Oregon Water Resources Department

SUBJECT Scenic Waterway Interference & General/Local Surface Water Impact Evaluation for Deschutes Ground Water Study Area

PUBLIC INTEREST REVIEW FOR GROUND WATER APPLICATIONS

TO: Water Rights Section Date 9/26/2012
 FROM: Ground Water/Hydrology Section K. Lite
Reviewer's Name
 SUBJECT: Application G- 17565 Supersedes review of _____
Date of Review(s)

G-17565: Sisters Quadrangle

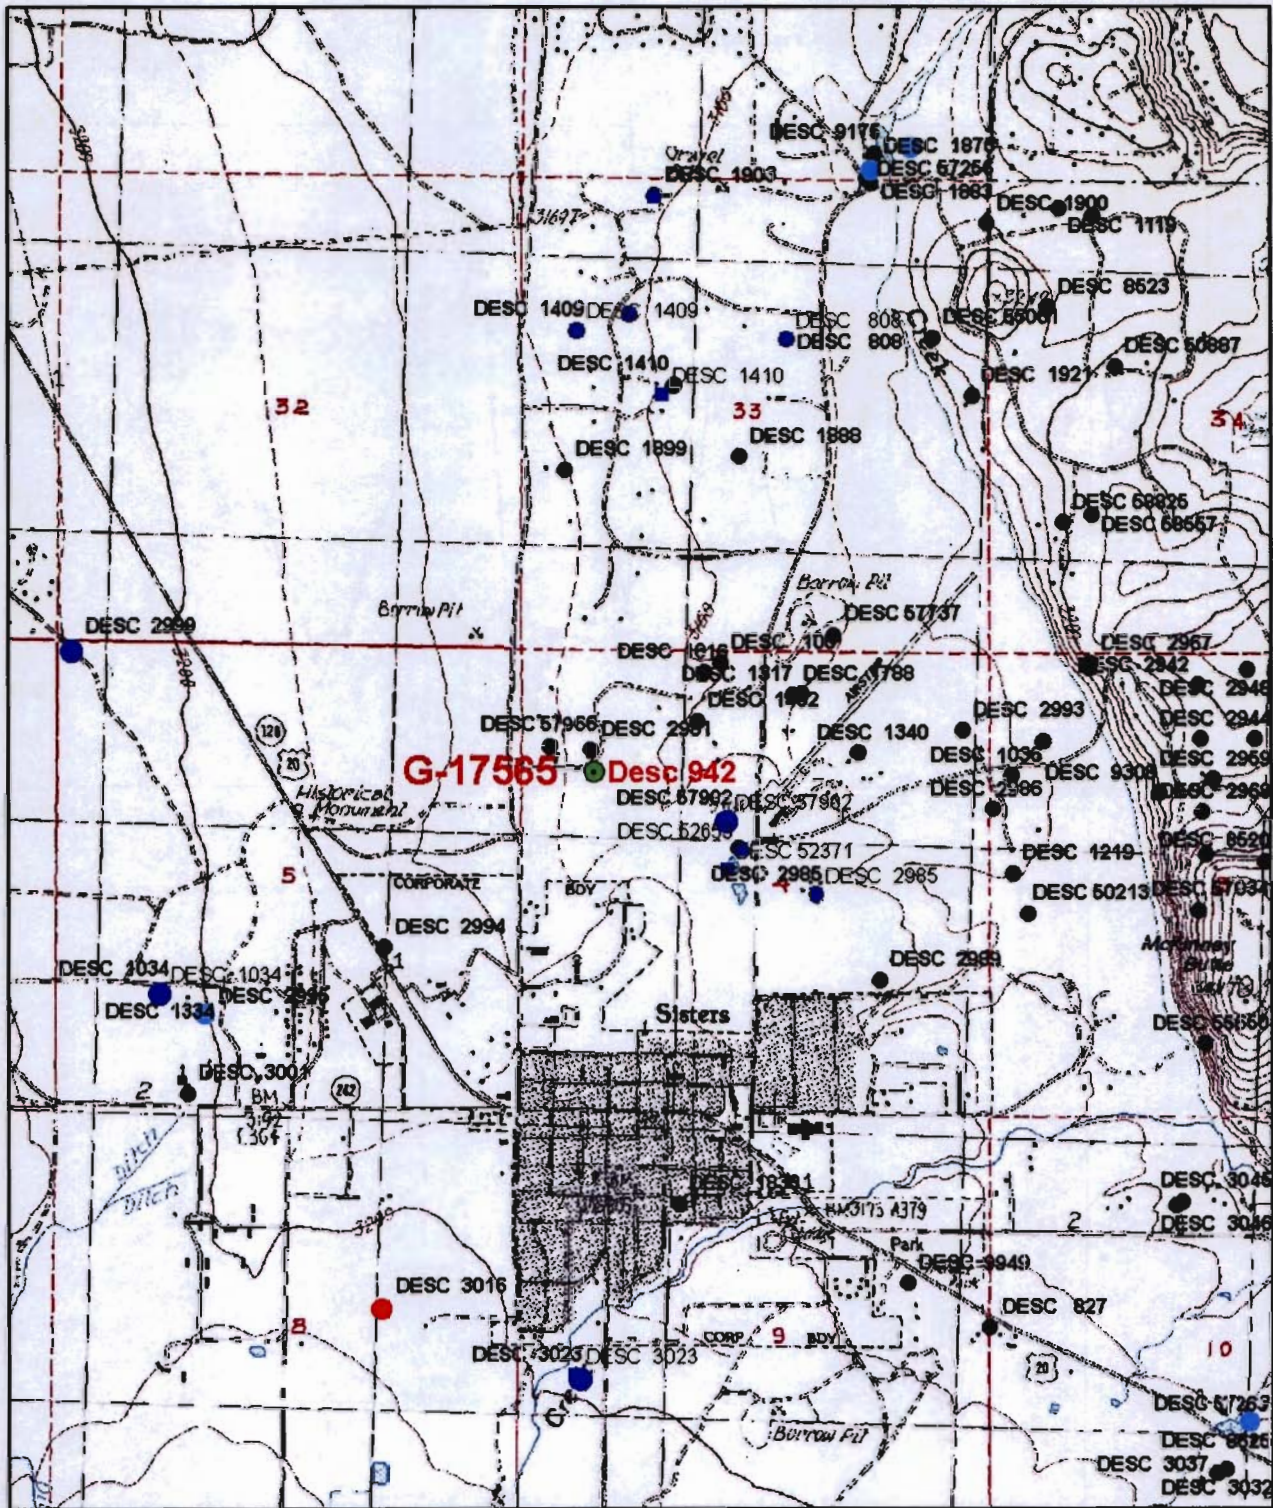
B3. Ground water availability remarks: THE NEAREST STATE OBSERVATION WELL IS OBS WELL 116 (DESC 3016), ABOUT 1.2 MILES TO THE SOUTHWEST. IT HAS BEEN MONITORED PERIODICALLY SINCE 1962. STATE OBSERVATION WELL 116 APPEARS TO BE IN DYNAMIC EQUILIBRIUM. THE LONG-TERM TREND SHOWS A DECADEAL-SCALE WATER LEVEL FLUCTUATION THAT IS COINCIDENT WITH CLIMATE CYCLES. THE DECADEAL FLUCTUATION HAS A MAXIMUM AMPLITUDE OF APPROXIMATELY 20- FEET. SINCE 2000, THE WATER LEVEL DROPPED ABOUT 19 FEET AS A RESULT OF DECREASED RECHARGE, BUT HAS RECOVERED ABOUT 11 FEET SINCE 2006 DUE TO INCREASED RECHARGE.

REGIONAL GROUND WATER FLOW IS NORTHEAST TOWARDS THE REGIONAL DOWN-GRADIENT DISCHARGE AREA (WHYCHUS CREEK) ABOUT 2.1 MILES FROM THE POA.
